AGENDA
PLANNING AND ZONING COMMISSION MEETING
CITY OF CREVE COEUR, MISSOURI
MONDAY, MARCH 1, 2021
6:30 PM

1. Application #21-005: Minor Site Development Plan Approval for the Sports Court Lighting for Property At 320 N. Mosley Road

APPLICATION TO PLANNING AND ZONING COMMISSION #21-005: FOR A MINOR SITE DEVELOPMENT PLAN APPROVAL FOR THE SPORTS COURT LIGHTING FOR PROPERTY AT 320 N. MOSLEY ROAD

Figure 1: Applicants site plan and light fixture detail, and Staff photo of the lighting installed on the site.

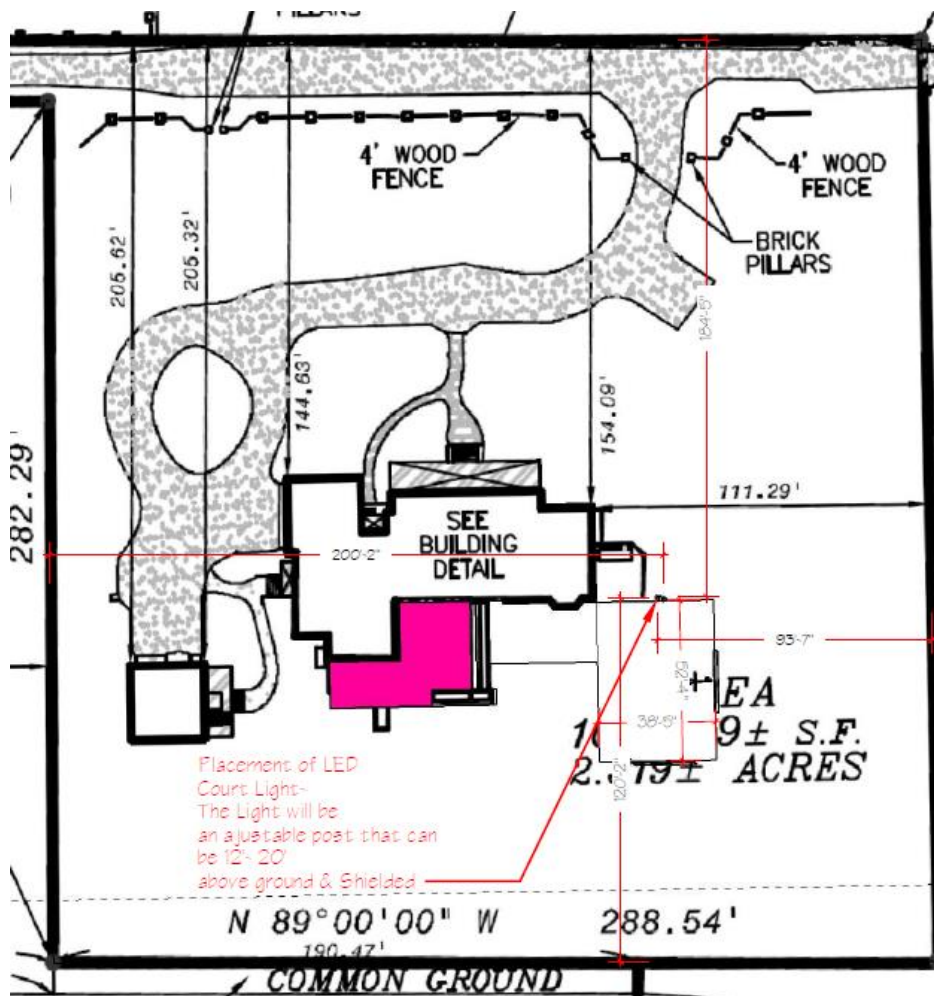
The Applicant is seeking approval of the previously installed LED pole mounted light fixture for the property at 320 N. Mosley Road. The game court and light fixture were installed in November of 2019 without proper approval from the City, including a site improvement permit. It also appears that the improvements moved the site over the 25% maximum site coverage, however a full site plan and final survey has not been submitted. The site coverage is being reviewed as part of a separate application for a future pool project, where the reported coverage is 27.5%. The Applicant has indicated that the light fixture was installed at 22 feet in height but could be lowered.

1. The Applicant is required to submit a Building Permit application, as required by Article II of the Building Code for the light fixture consistent with plan as bound together and submitted in conjunction with Application #21-005 as submitted by Envisioning Green, and with all conditions of approval.
2. The Lighting fixture shall be lowered to a maximum height of 16 feet.

Figure 2: Applicants Photometric Plan of the Lighting Levels of the Game Court.

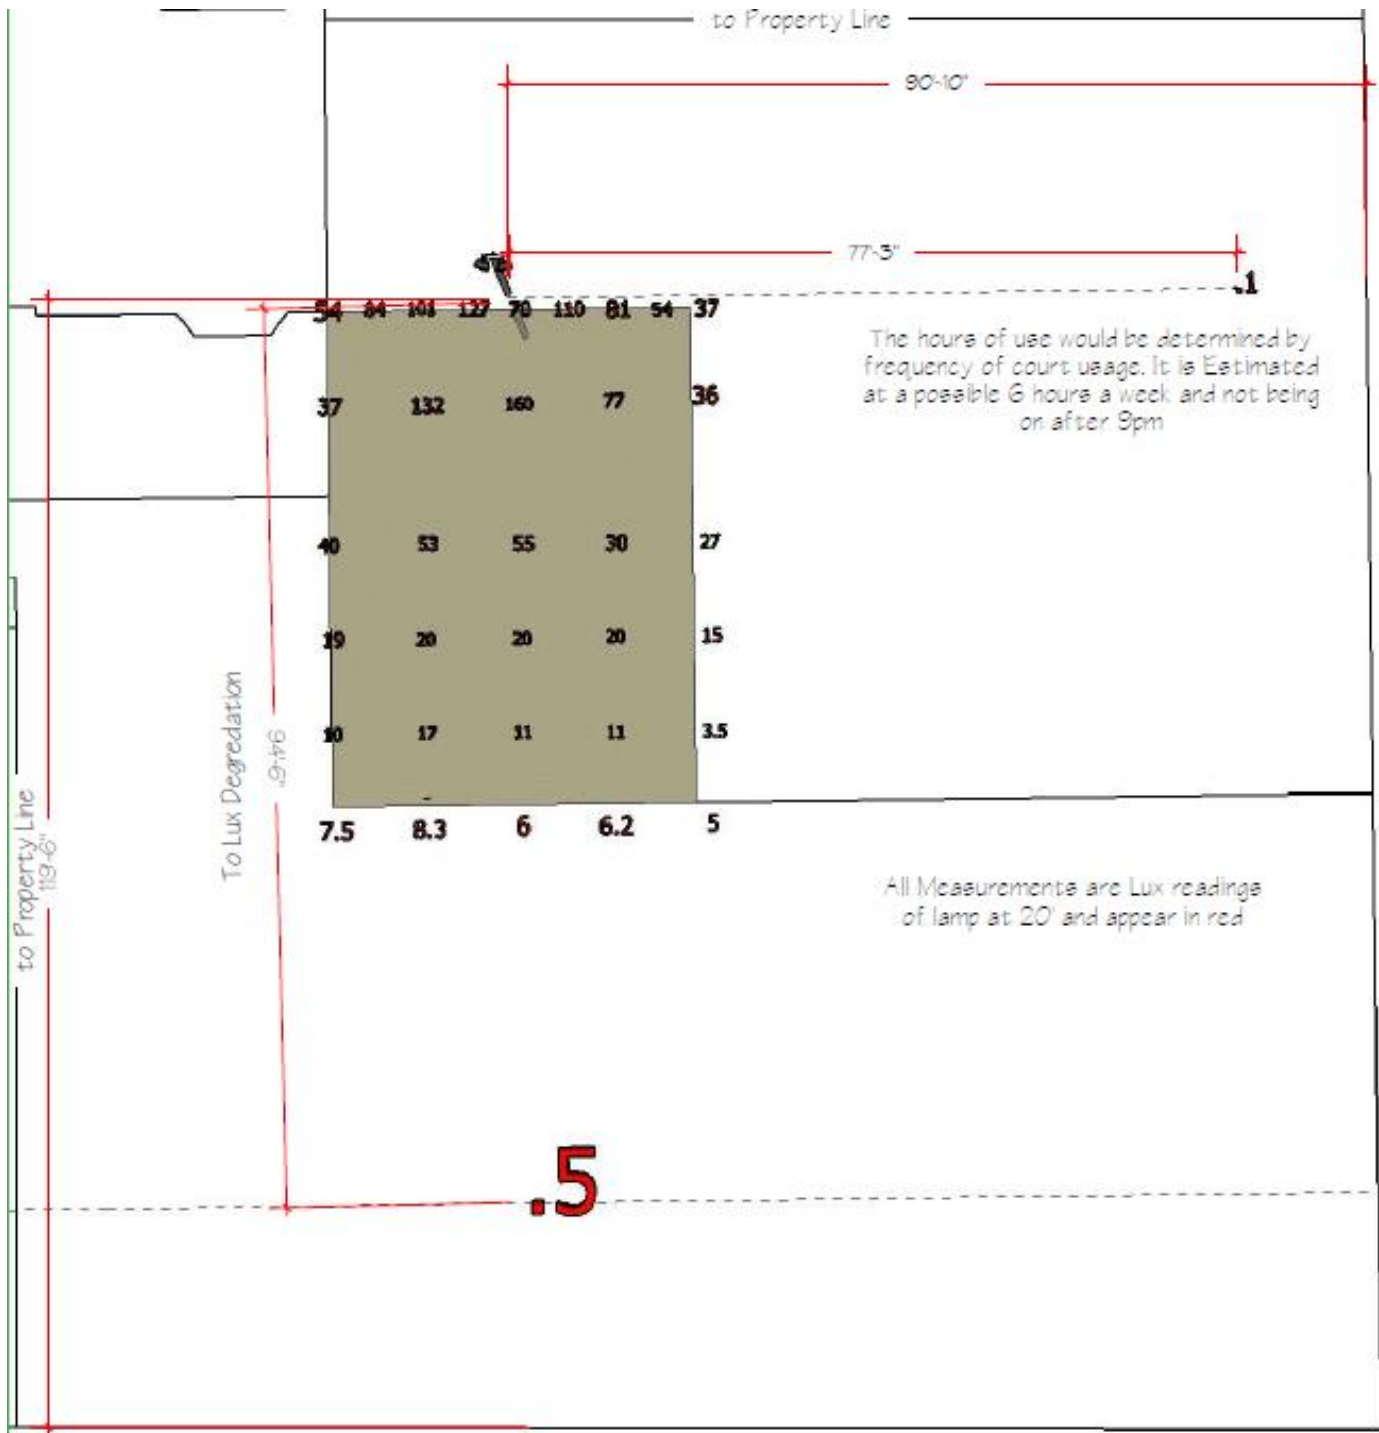
The Applicant has indicated the lighting fixture was installed at 22 feet; however, it can be lowered. The Photometric Plan indicated that the lighting is at less than one foot candle within the property lines, at .1 fc approximately 13.5 feet from the east property line (closest residents), and 0.5 fc 25 feet from the south property line. The Applicant has indicated on the photometric plan that the lighting is not likely to be in use after 9PM. Staff does recommend that the lighting should be lowered to 16 feet, to be consistent the regulations for lighting in the residential districts. The Commission should hear from any adjacent residents, and if they find that the lighting as installed is sufficient, they will need to revise the recommended conditions of approval.
